**RESPONSE TO COUNCIL'S RFI LETTER (DA-2017/224)
152-200 & 206 ROCKY POINT ROAD, KOGARAH**

We refer to the above matter and your letter dated 14 June 2017. This response has been prepared by JBA on behalf of the applicant Rocky Point Road Development Pty Ltd in relation to Development Application (DA) DA-2017/224, constituting a response to the issues raised by Council in that letter dated in order to assist Council in its continued assessment of the application. It is noted that a revised Clause 4.6 Variation Request and response to all traffic related matters will be provided separately in due course.

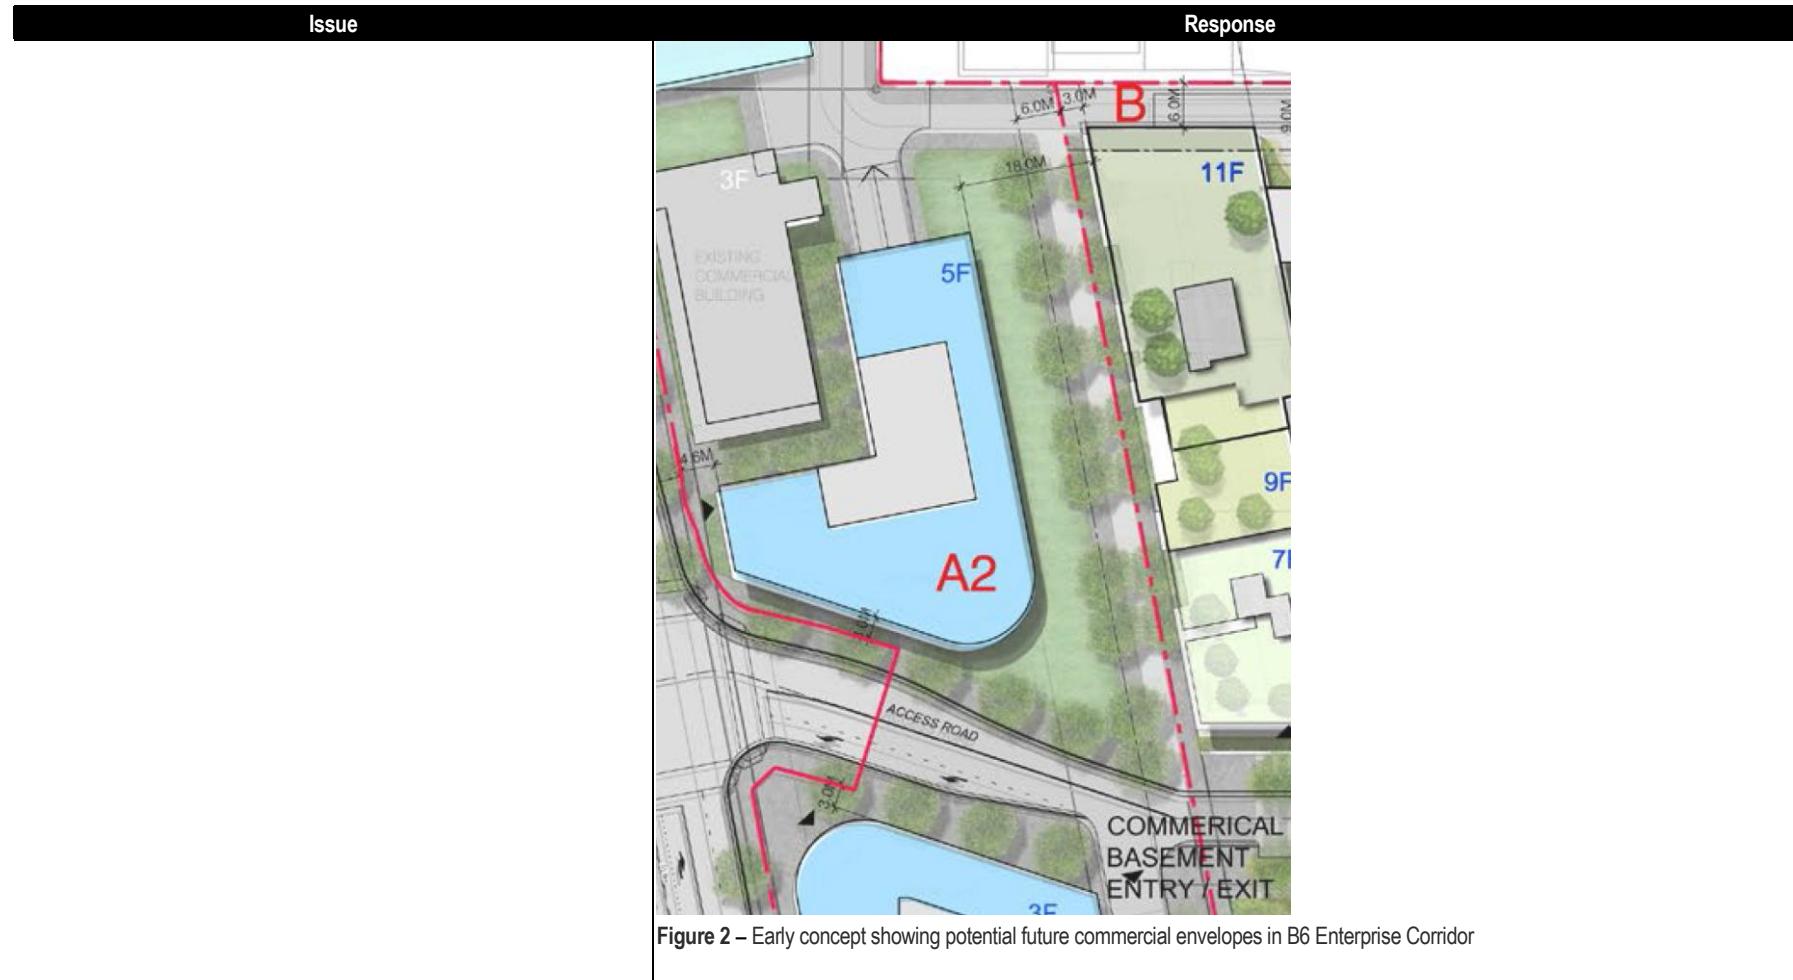
e) Rocky Point Road Frontage – details are required to demonstrate how the Rocky Point Road frontage will be treated until a future application is lodged and determined for this part of the site. Consideration to be given to screen planting.	<p>It is noted that the demolition of existing buildings on the site is not proposed as part of this DA, and that this demolition has already occurred through a separate approval process under <i>State Environmental Planning Policy (Exempt and Complying Development Codes) 2008</i>. Accordingly, the only works to the Rocky Point Road frontage proposed as part of this DA relate to the roadworks along Rocky Point Road and the construction of the internal access road, which forms a limited part of the road frontage.</p> <p>It is noted that no demolition will occur for the length of Rocky Point Road between Production Avenue and through to the southern boundary of 168 Rocky Point Road (which is not included in the subject proposal and is not earmarked for demolition). This constitutes a frontage length of over 100 metres of the overall site which will not be a works zone.</p> <p>For the limited portion of Rocky Point Road which will be subject to construction works, typical construction fencing will restrict access to the development site. The developer intends to prepare a lodge a development application for the B6 zoned land prior to substantial construction works commencing, which will resolve the interface of the overall site to Rocky Point Road.</p>

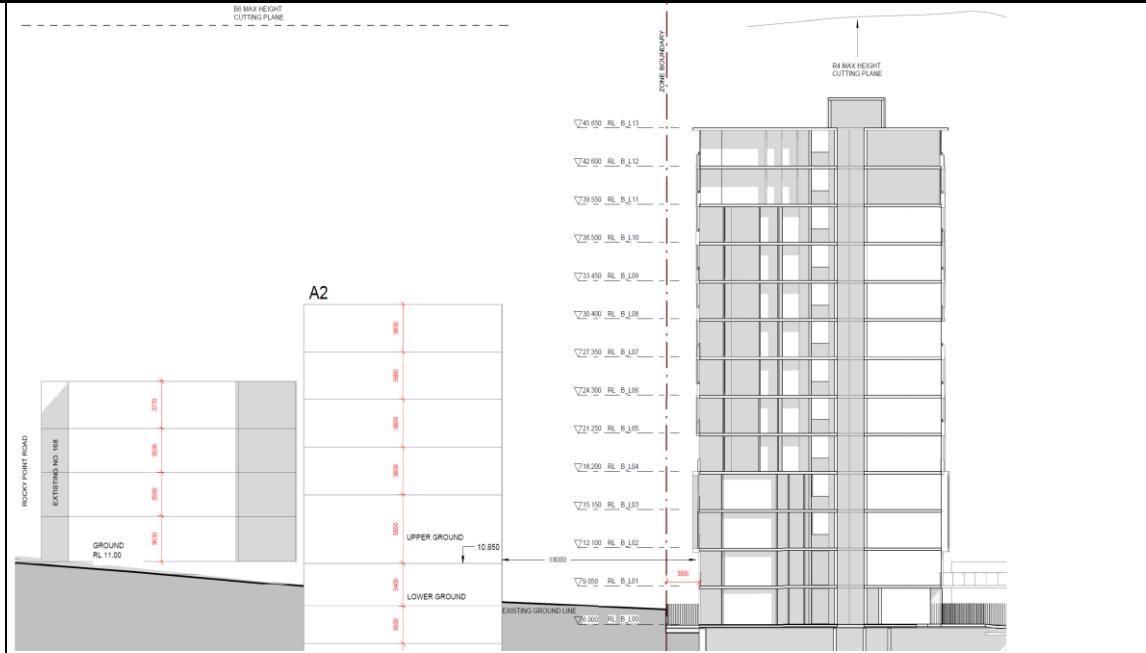
<p>4. Existing Right of Way / Stormwater Easement</p> <p>RMS advises that the following easements are in their benefit:</p> <ul style="list-style-type: none"> ▪ <i>Right of carriageway 5.5 wide (shown on DP599502) (right of carriageway)</i> ▪ <i>Easement for drainage 1.83 wide & 2.45 wide (shown on DP379619 and modified by DP612212) (easement for drainage)</i> <p><i>Council's Engineers have been provided with a copy of the correspondence between RMS and JQZ regarding ownership of the stormwater easement. They have advised that the ownership issue must be resolved with RMS.</i></p> <p><i>If the stormwater pipe(s) / easement(s) are found to be Council's, then relocation of the network is supported in principle. Council's Engineers are assessing the proposed stormwater pipe relocation and the associated overland flows / flooding implications associated with these works. Further information will be provided once their assessment has been completed.</i></p>	<p>The applicant is following this up directly with the RMS and will advise Council on the outcome prior to determination.</p>

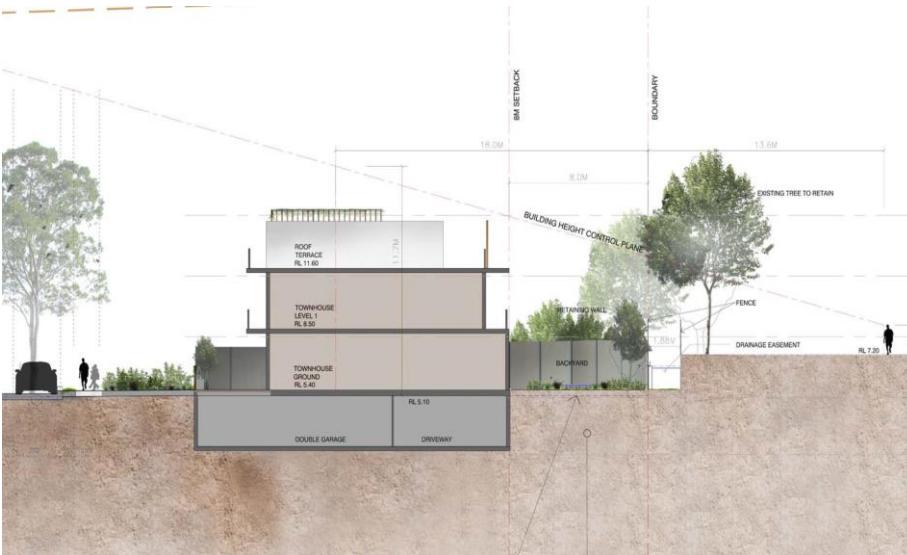
(2) <i>The balconies for many units are not considered to be an extension of the indoor living areas in accordance</i>	Objective 4E-2 of the ADG seeks to ensure that primary private open spaces and balconies are appropriately located to enhance liveability for residents. The layout of apartments which Council have noted do form an extension to the indoor living areas, but in many cases, have a perpendicular relationship. The benefits of this arrangement are:

Issue	Response
<p>with Objective 4E-2 of the ADG and RDCP 2011. Many of the proposed balconies are located to the side of the main living areas and are not easily accessible. Also, the main area of private open space (balcony) in many units is located adjacent to a bedroom window / door and would conflict with the amenity of residents. The layouts of these units should be modified.</p>	<ul style="list-style-type: none"> ▪ Maximisation of the eastern and western exposure of the buildings to living rooms, balconies and bedrooms, maximising direct sunlight to all living areas within the apartment and to private open spaces ▪ Maximisation of balcony use by allowing access from the main living areas and bedrooms, which is encouraged by the ADG (refer to Figure 4E.4). <p>In these circumstances, the apartments still achieve the Objective of 4E-2 and Design Guidance, as they still form an extension of the living space, they predominantly face east, west or north as required by the ADG, and the longer sides of balconies are generally orientated with the longer side facing outwards to optimise daylight access into adjacent rooms.</p> <p>Because of maximum building depth requirements and building separation requirements, as well as the intention to ensure living spaces and private open spaces receive direct sunlight as required by the ADG, re-orientating these balconies to form a parallel extension of the apartments in question would result in a sub-optimal outcome and a development which does not achieve all the objective of the ADG which have been appropriately balanced in the context of the proposed design.</p> <p>It is not agreed that the siting of private open spaces, often with a direct connection from bedrooms as encouraged by the ADG, will conflict with the amenity of residents in these circumstances, particularly as these arrangements are quite common and are often the preference of purchasers.</p>
